PROJECT
80 CHARLOTTE STREET

DRAWING TITLE
GA LEVEL 09 ROOF PLAN

DRAWING NO.
A-07-P2111

DRAWING TITLE
POCKET PARK SOUTH ELEVATION
PLAN, ELEVATION AND SECTION
CHITTY STREET

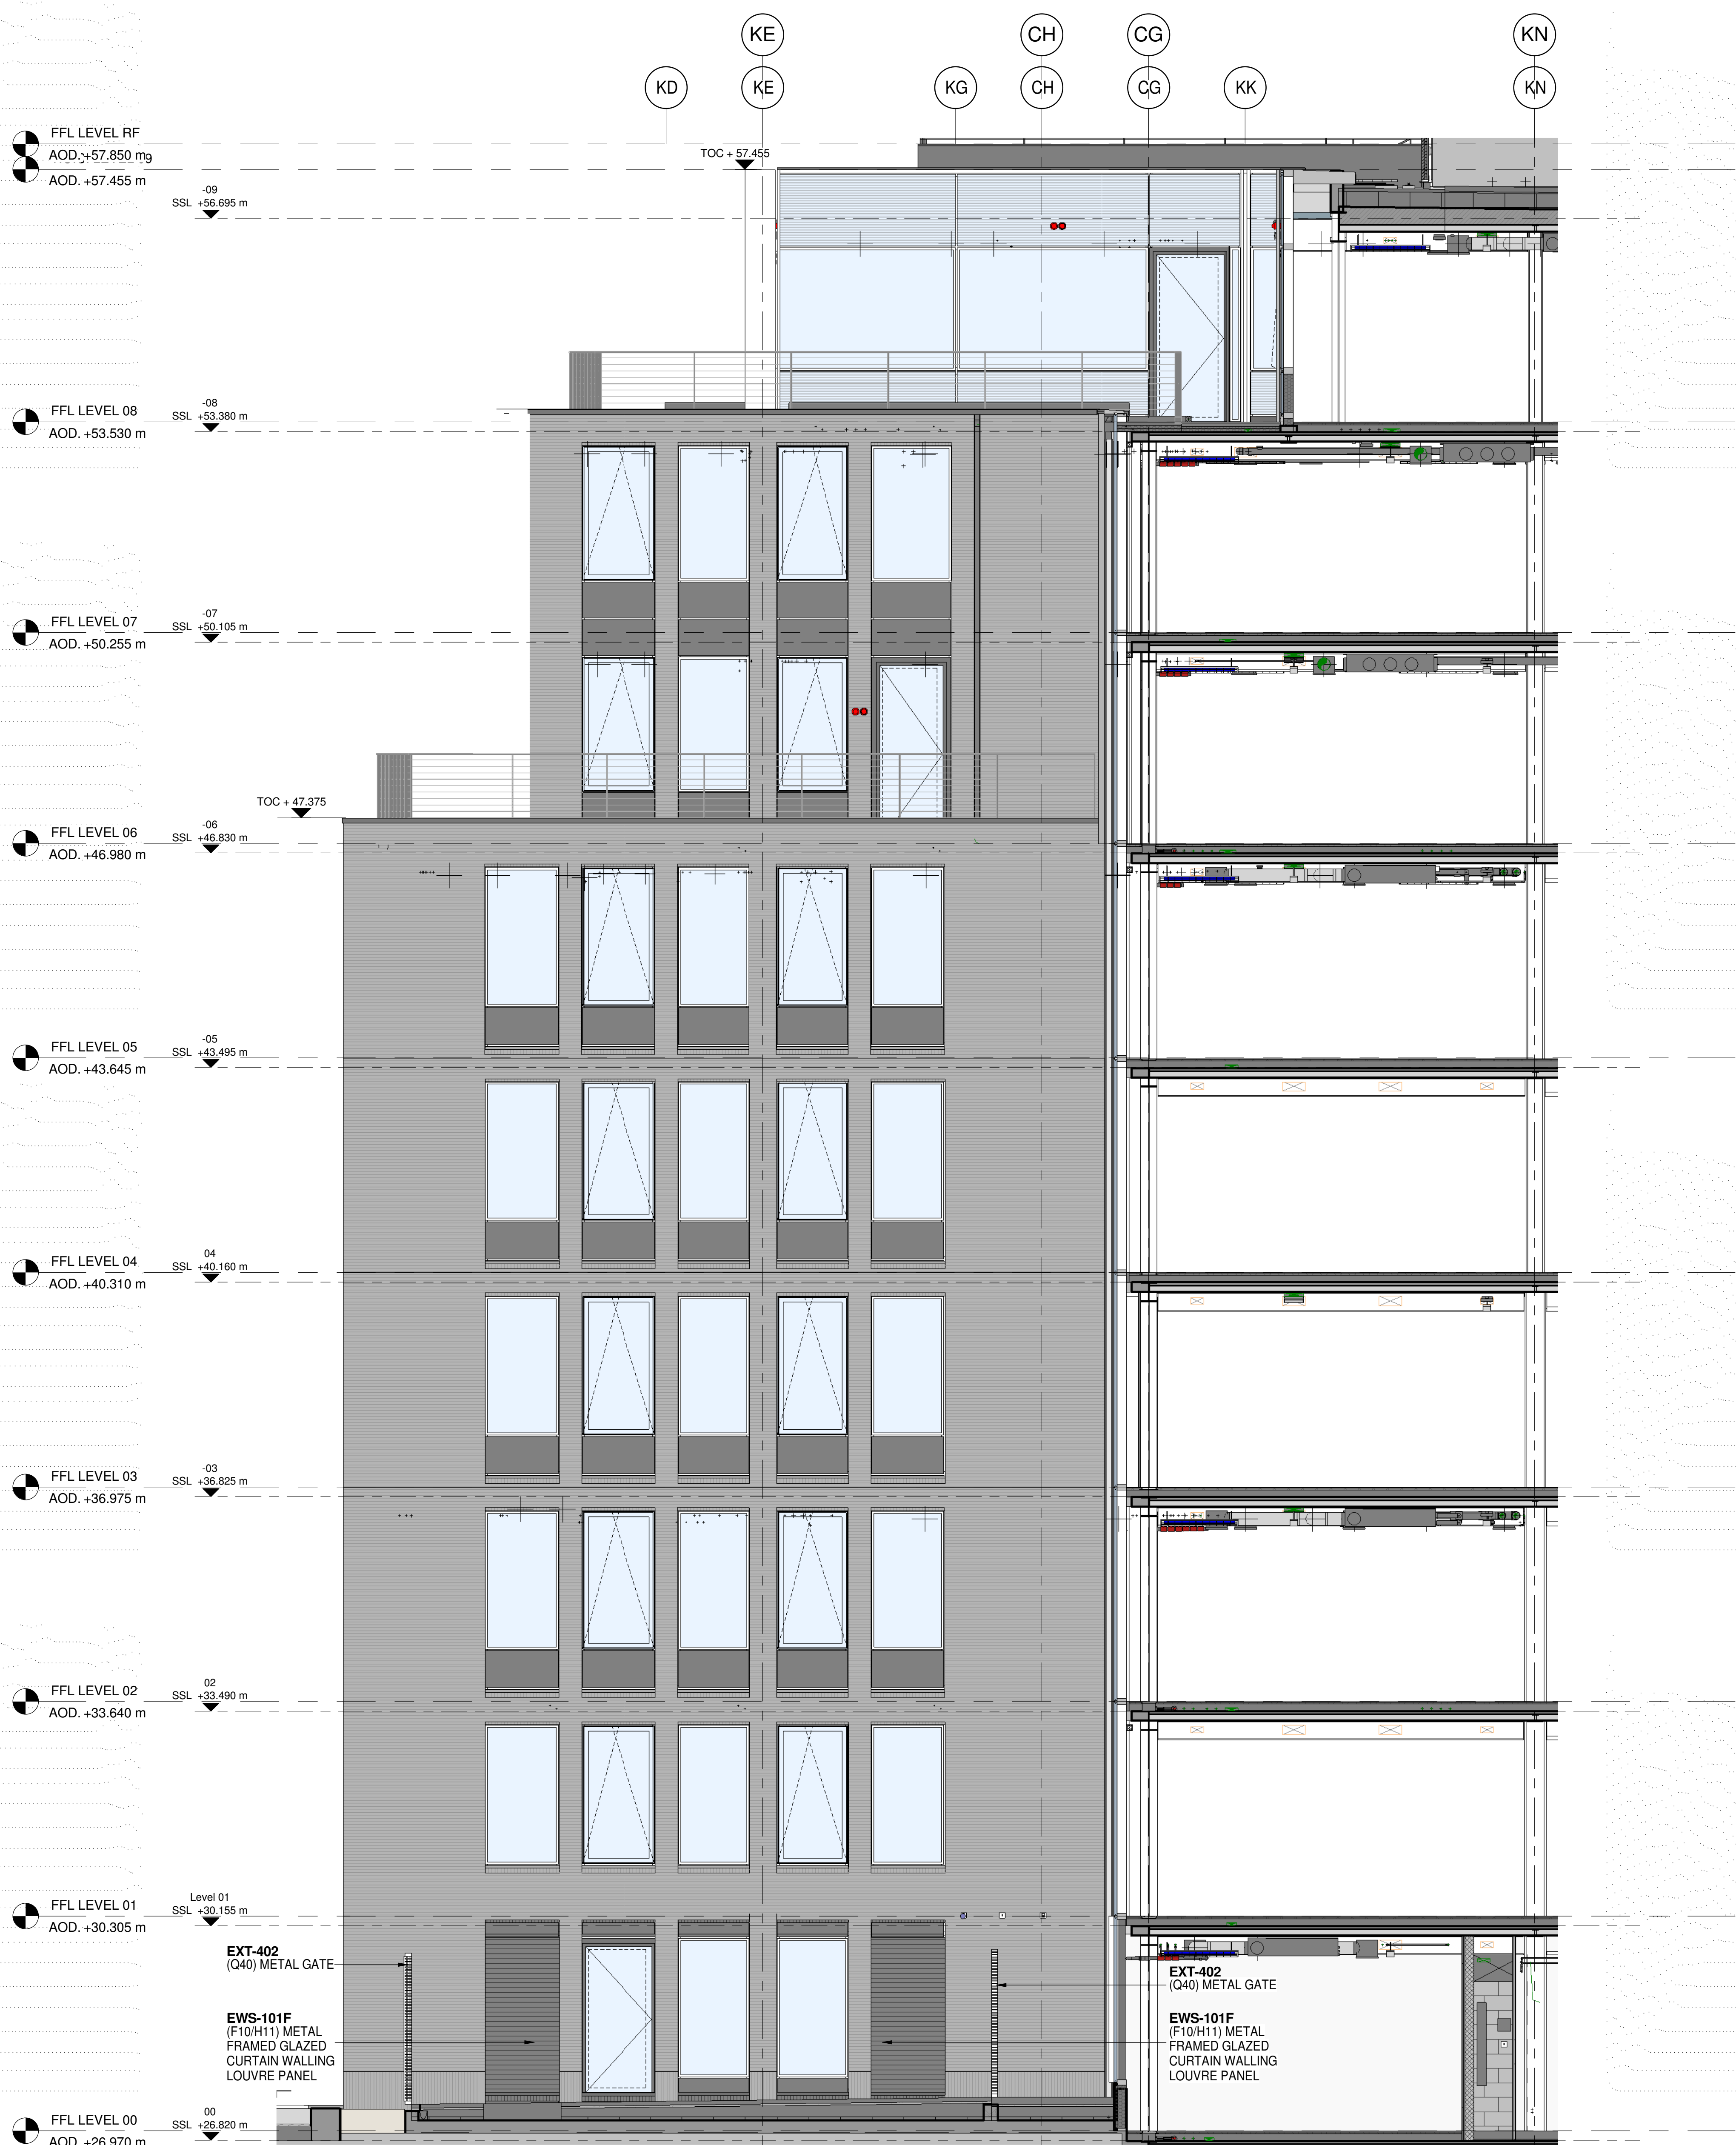
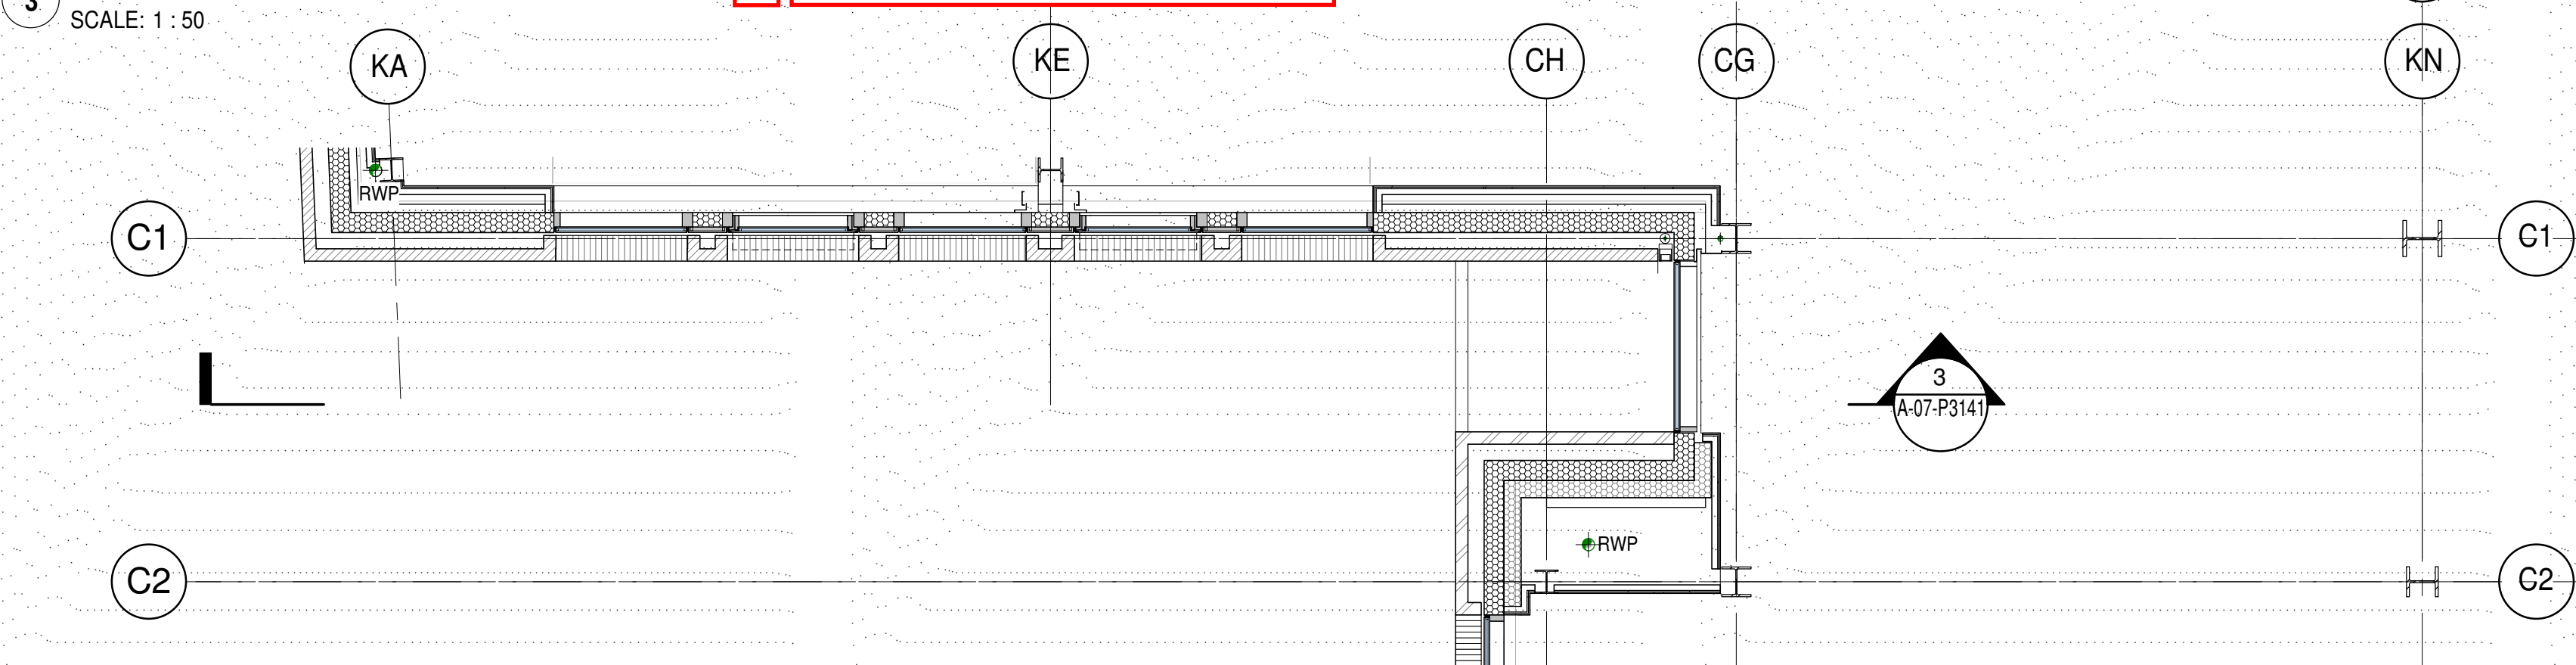
1. Removal of bridge link on Charlotte St
2. Solar thermal panel adjustment
3. Lift overrun height increase
4. Base building roof plant height (AHU)
5. Tenant plant space louvre adjustment
6. Terrace and lightwell level door rationalisation
7. Brick weave refinement
8. Chitty Street Gate design
9. Pocket Park louvres readjustment
10. Rainwater pipe integration
11. Loading bay entry additional roller
12. 67-69 Whitfield Street roof plant access route
13. 67-69 Whitfield Street terrace parapet & balustrade

REVISIONS BY COMMENTS
- AMENDED AS PER MPX COMMENTS
- BRICK WEAVE PATTERN AMENDED
- LEVEL OF TOP OF VERTICAL BRICK AMENDED
- AMENDED AS PER COMMENTS
- PROP PLATE CHANGED, DOORS AMENDED, DOOR HANDLES/KNIVES/FIXATIONS REMOVED AS PER MPX INSTRUCTION
- PRECAST CONCRETE PANEL AMENDED, GROUND FLOOR THRESHOLD INCREASED
- LOUVRE ADDED
